ADDENDUM NO. CC-1

TELEGRAPH DISTRICT
401 BUILDING RENOVATION
LINCOLN, NEBRASKA
DLR GROUP PROJECT NO. 10-16202-00

February 26, 2016

POWER PLAN, BASEMENT LEVEL
SCALE: 1/8" = 1'-0"

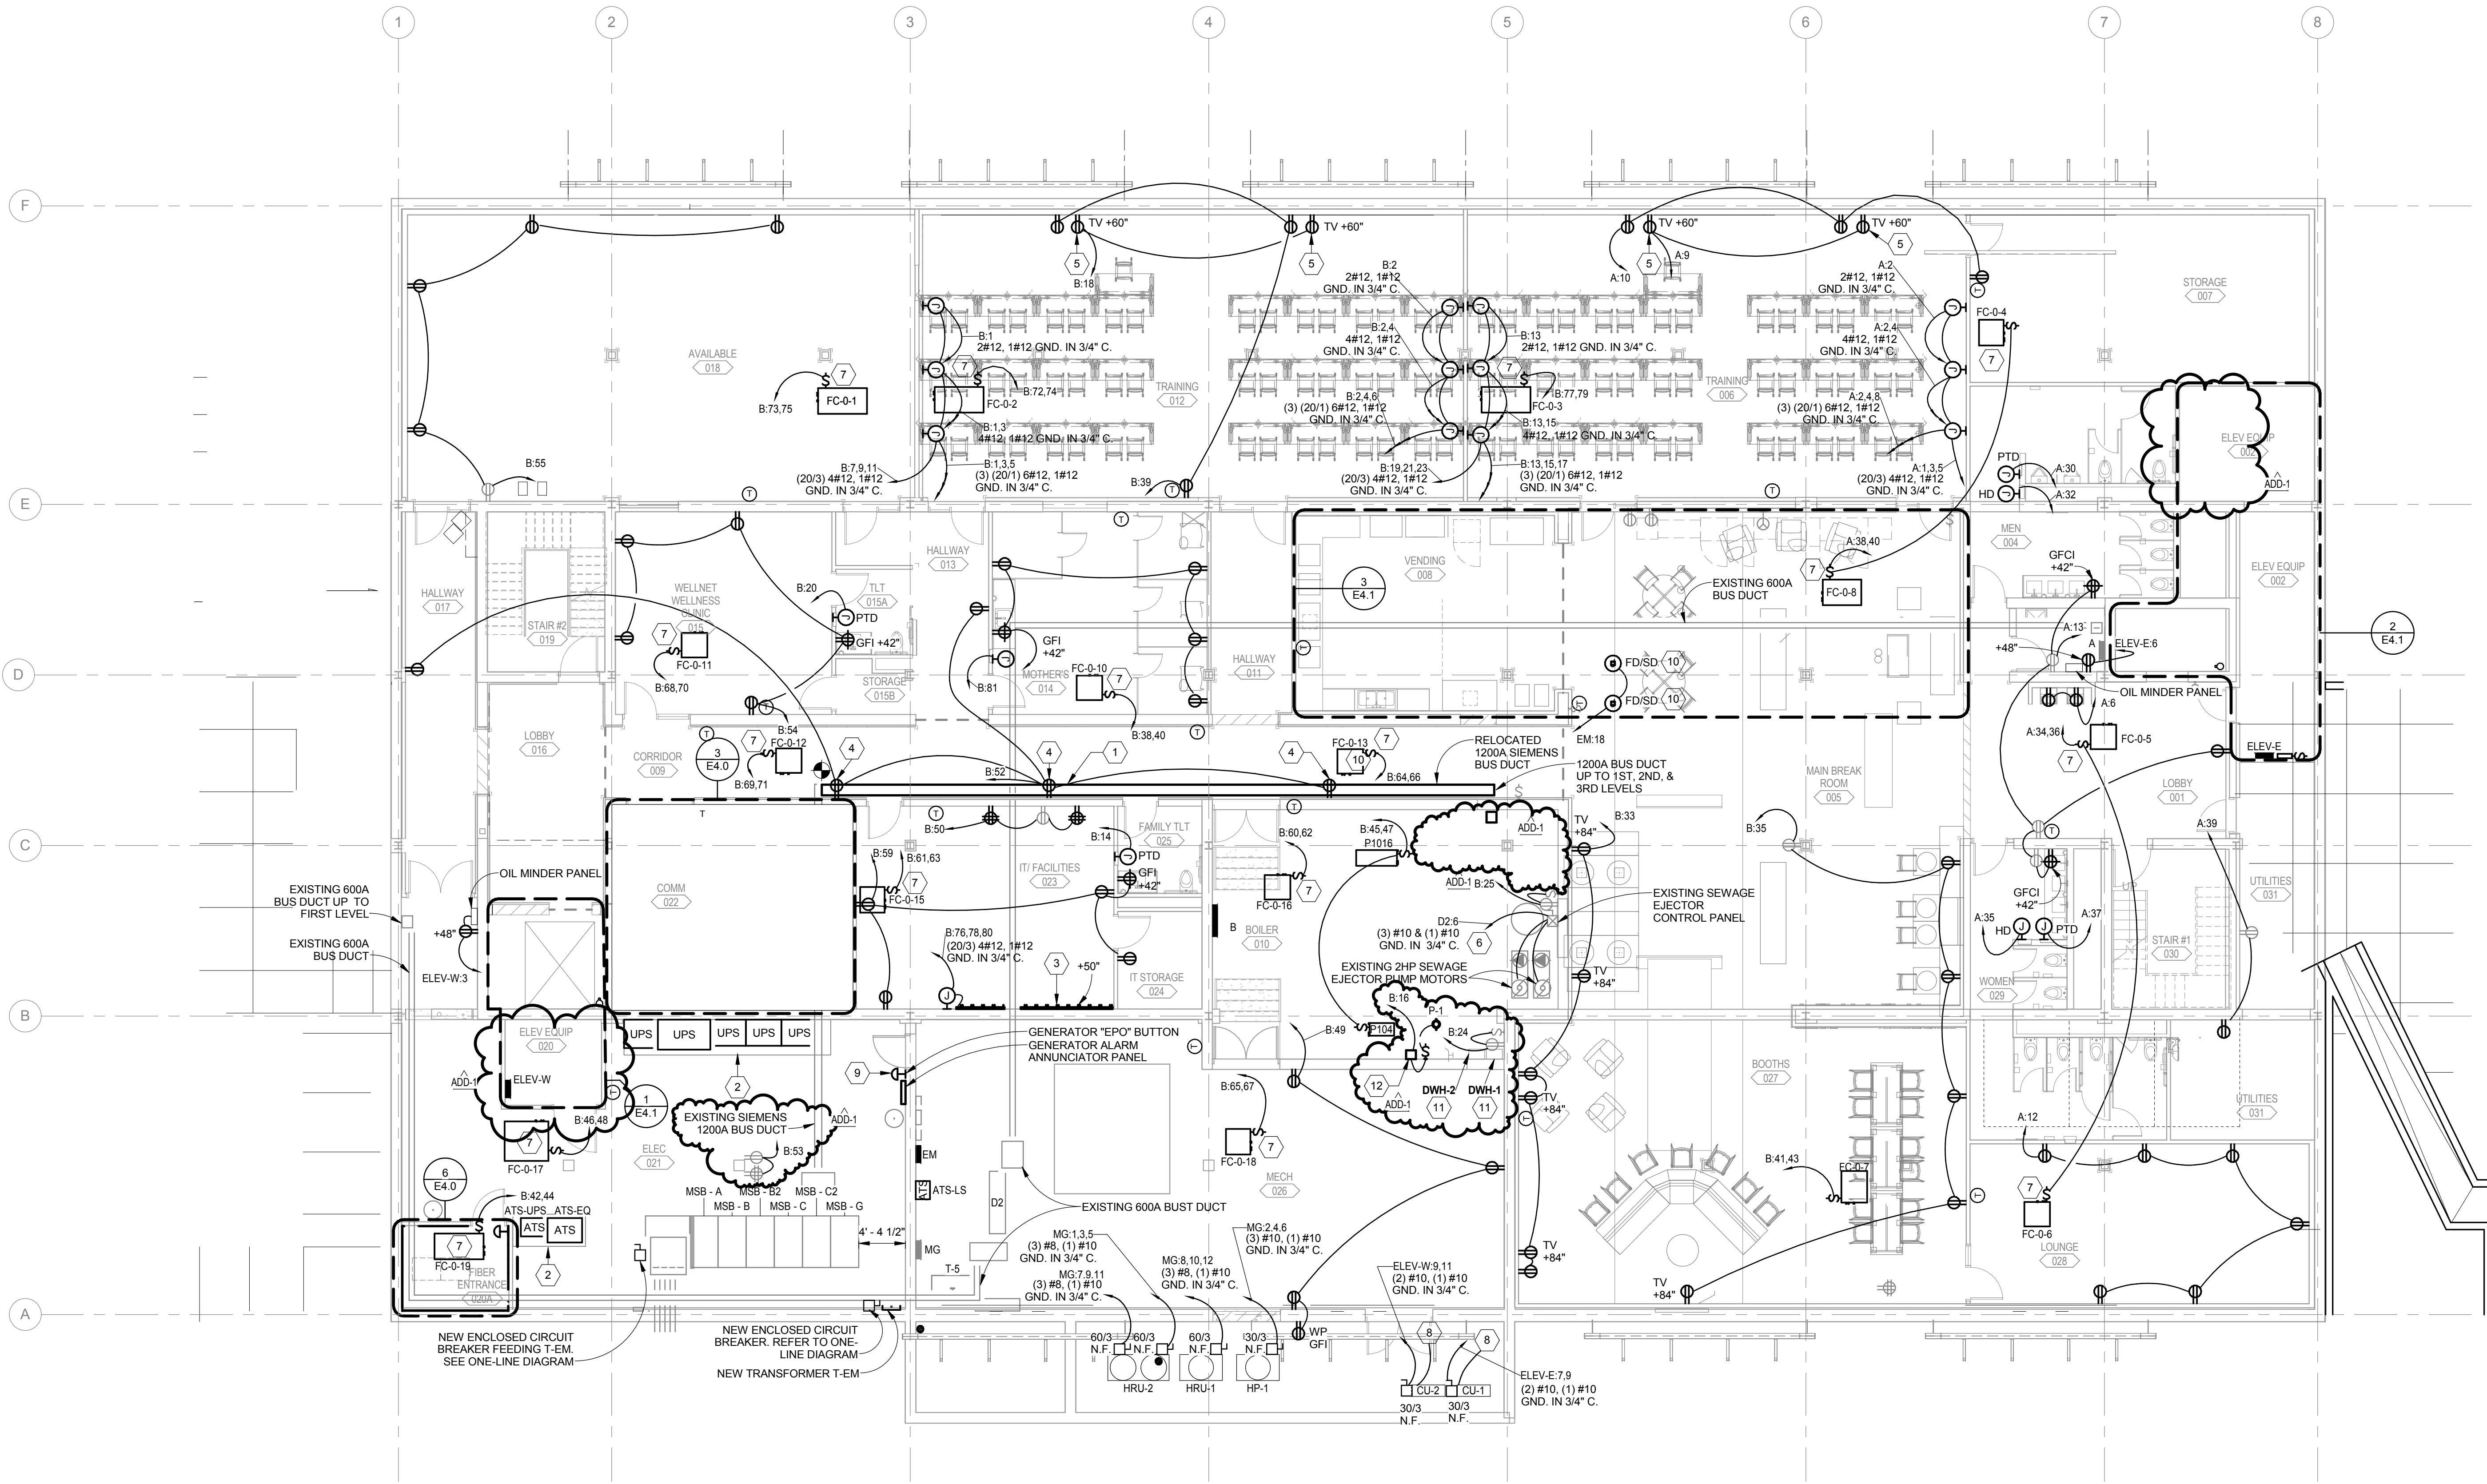
ITEM NO. 32 DRAWING E1.0 POWER PLAN, BASEMENT LEVEL

- A. Revise drawing as shown in the attachment E1.0 for modifications to the power plan.

E1.3

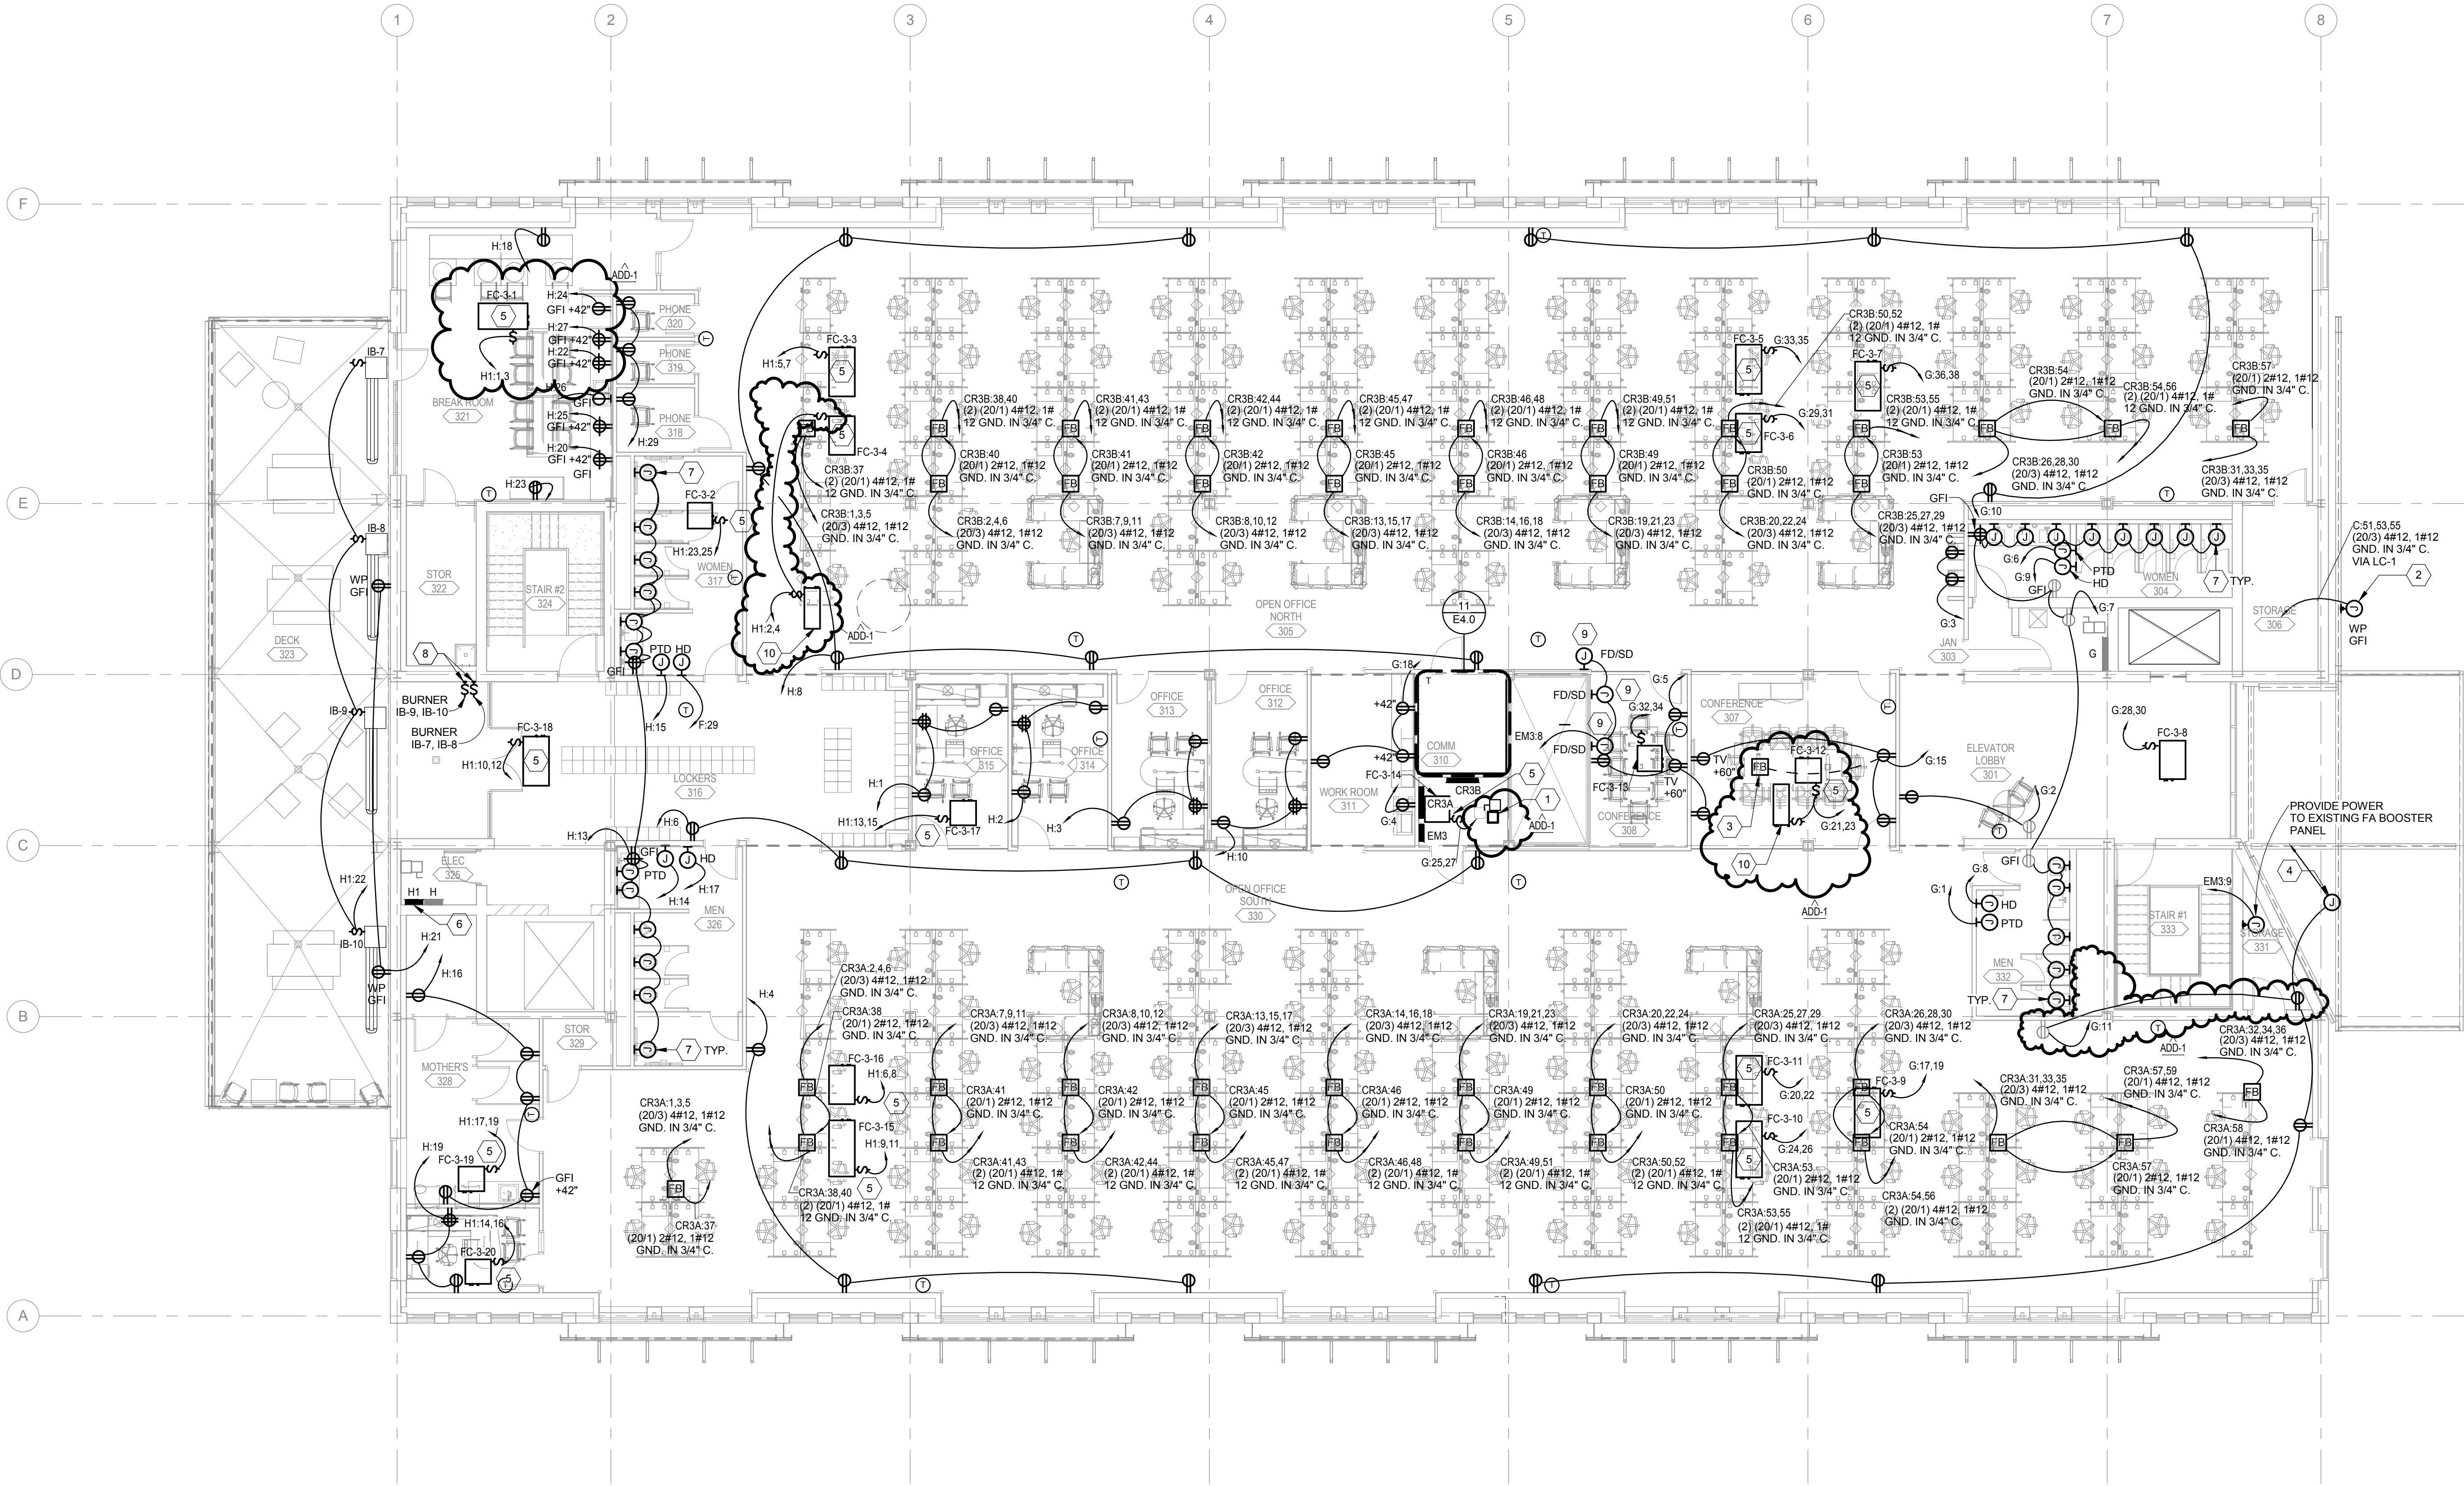
ITEM NO. 35 Drawing E1.3 POWER PLAN, THIRD LEVEL

- A. Revise the location of fan coil FC-3-1 as shown in the attached drawing E1.3.
- B. Remove the text "400/3" from the disconnect switch shown on the 1200A vertical bus duct. Revise Keynote 1 to state the following: "RELOCATE AND EXTEND THE EXISTING SIEMENS 1200A ELECTRICAL BUS DUCT TO THE NEW 1ST, 2ND, AND 3RD FLOOR ELECTRICAL CLOSETS. PROVIDE ADDITIONAL NEW LENGTHS OF BUS DUCTS AND FITTINGS AS REQUIRED. REFER TO THE ONE-LINE DIAGRAM FOR BUS DUCT DISCONNECT REQUIREMENTS FOR EACH CONNECTED PANEL."

- C. Revise the drawing to provide power to the Mechanical BRANCH CIRCUIT CONTROLLER located adjacent to fan coil FC-3-12 as shown in the attached drawing E1.3. Add Keynote 10 state the following: "PROVIDE A POWER CONNECTION TO THE MECHANICAL BRANCH CIRCUIT CONTROLLER. PROVIDE A 15A, 2-POLE, 240V TOGGLE SWITCH AS A DISCONNECTING MEANS."

- D. Revise the drawing to provide power to the Mechanical BRANCH CIRCUIT CONTROLLER located adjacent to restroom Women 317 as shown in the attached drawing E1.3. Add Keynote 10 to state the

following: "PROVIDE A POWER CONNECTION TO THE MECHANICAL BRANCH CIRCUIT CONTROLLER. PROVIDE A 15A, 2-POLE, 240V TOGGLE SWITCH AS A DISCONNECTING MEANS."

- E. Revise the receptacles on circuit G:11 located near MEN 332 as shown in the attached drawing E1.3.
